BLM SCALAR FIX -Based on findbhudda's original design:
<http://www.midibox.org/dokuwiki/doku.php?id=findbuddha>

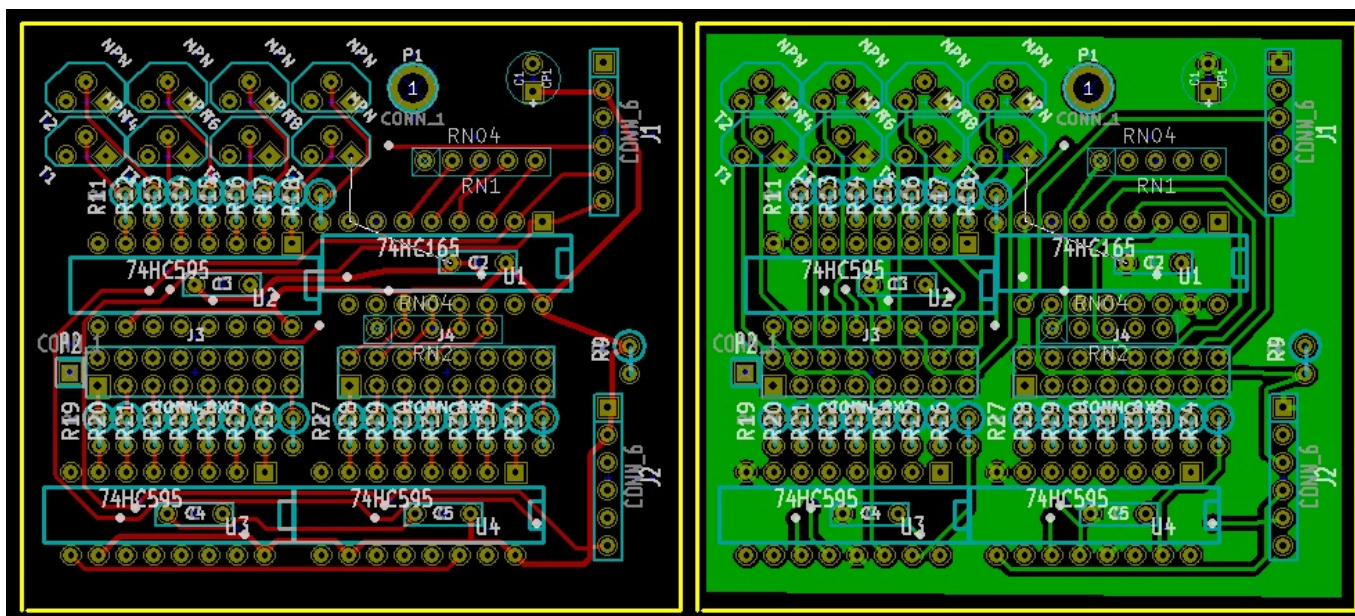
- blm-scalar.* contain an error. Pins I4-I7 are mirrored. This is easily fixed with a connector modification, and the blm-scalar module seems to work as intended.
- blm-scalar v1.1 attempts to fix this error. Moved connectors J1, J2, Resistor Net 1 and R9 to make room for corrections.

Corrected blm-scalar v1.1.brd [blm-scalar_v1.1.brd.zip](#)
